ADMINISTRATIVE DEVELOPMENT PLAN AMENDMENT  
 FILE NO. AA-02256-00175  
 see note 1  
*Richard [Signature]*  
 PLANNING DIRECTOR DATE 3/19/02

# Cottonwood Trails

## SITE PLAN FOR SUBDIVISION AND BUILDING PERMIT

CONSENSUS  
 January 10, 2001  
 Revised: February 13, 2002  
 Sheet 1 Of 8

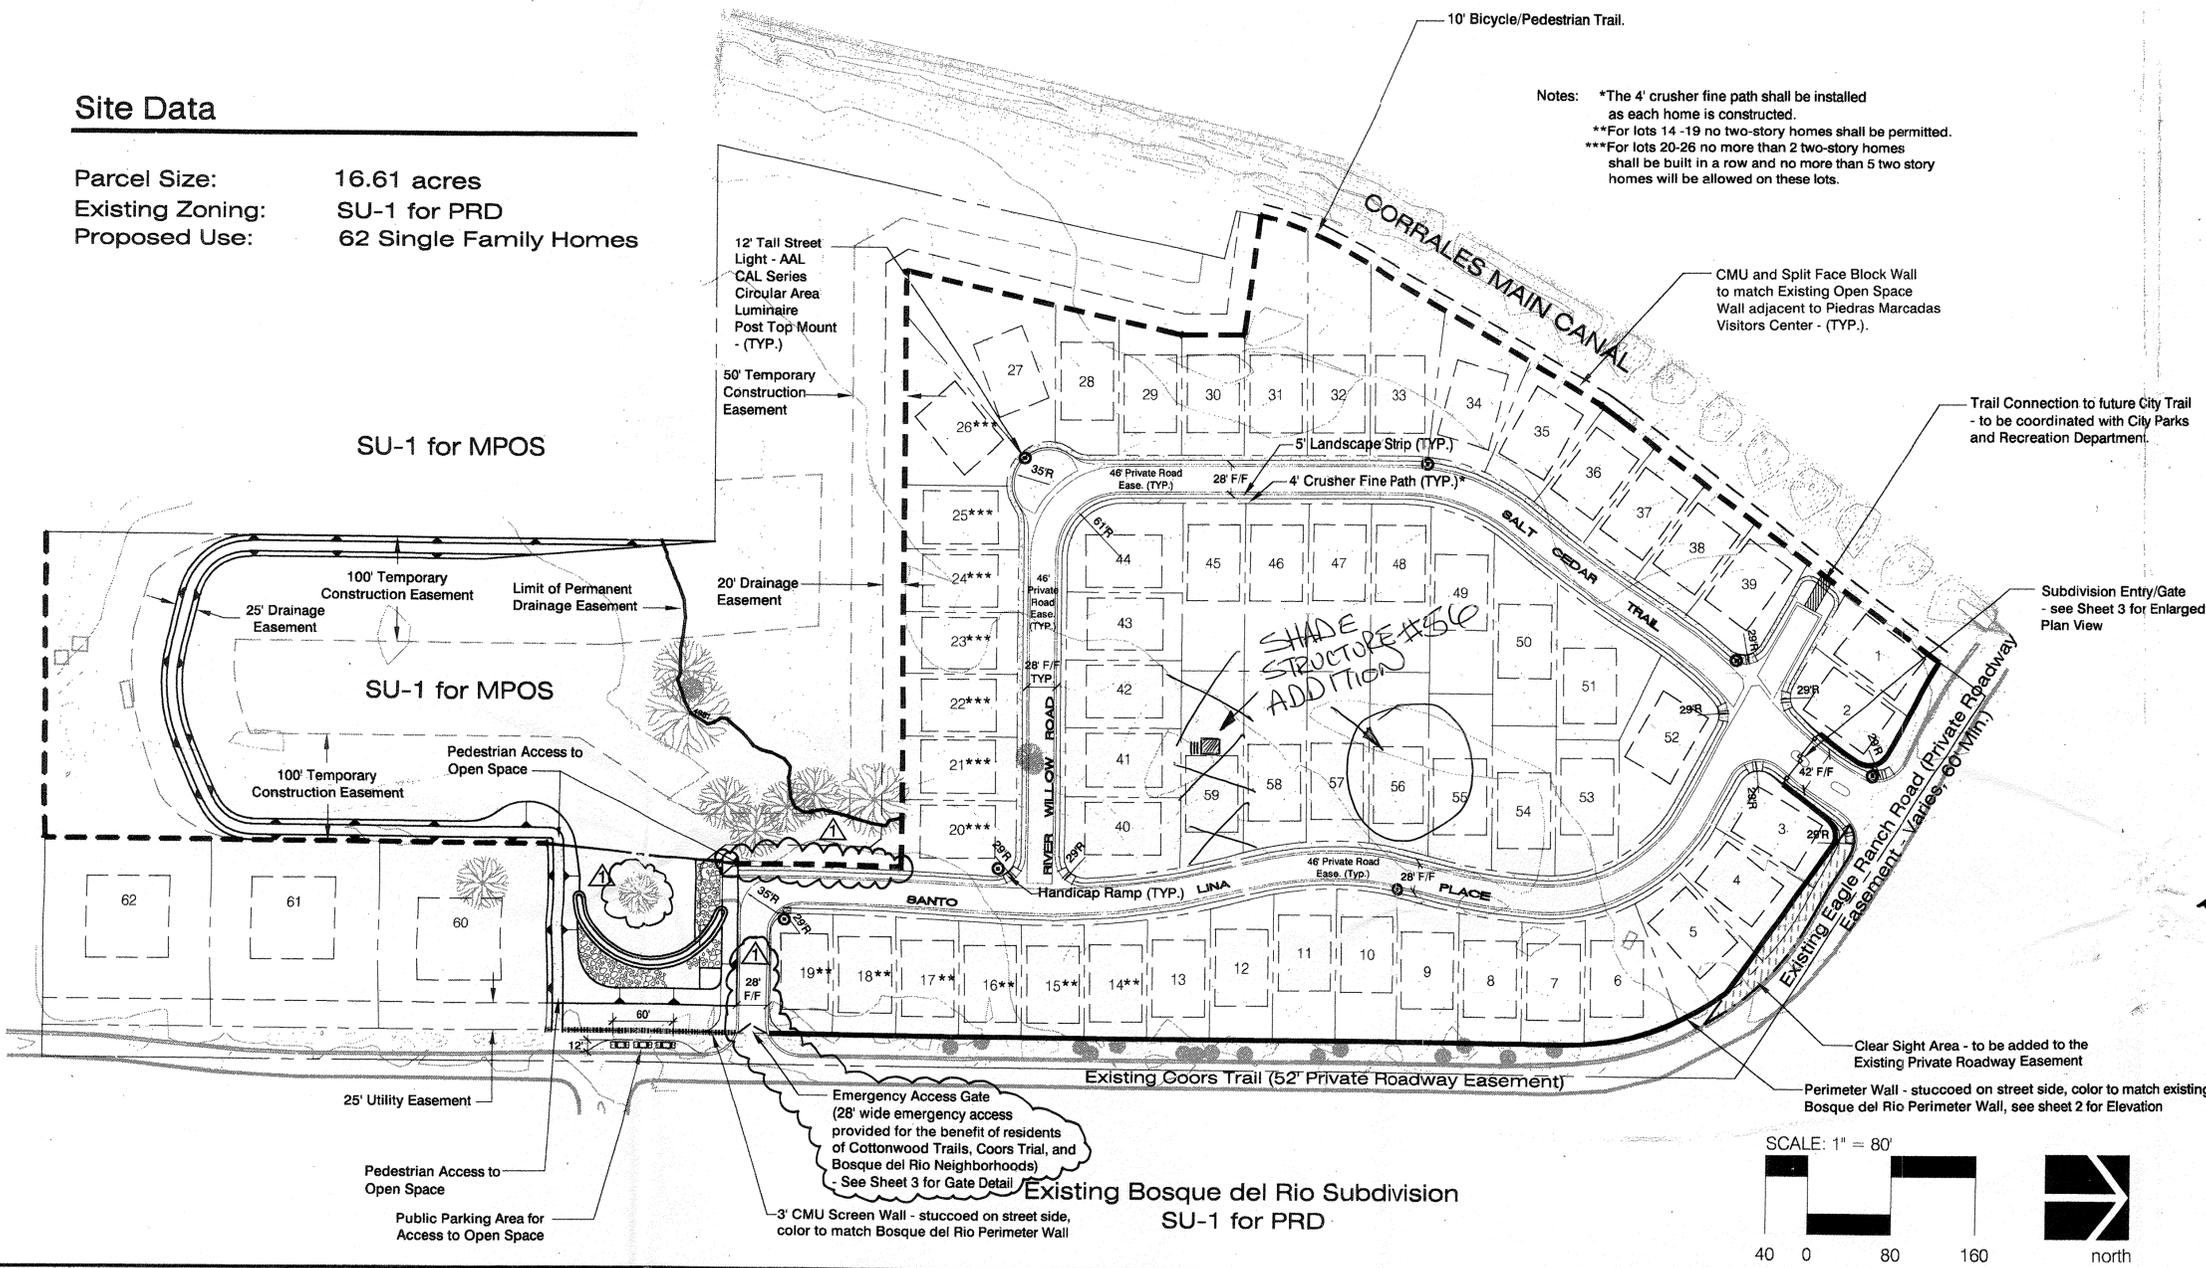
- Revised wall adjacent to City Open Space (Lots 18-26 & 60-62) to allow wrought iron view fencing (see new Sheet 3B).
- Added section of Open Space wall along the west side of Santo Lina Place (see Sheet 1).
- Revised note regarding existing cottonwood in the detention pond (see Sheets 2 & 3).
- Added Sheet 3B, Open Space Wall/Fence Plan.
- Modified Emergency Access per City DRC requirements (see Sheet 3).
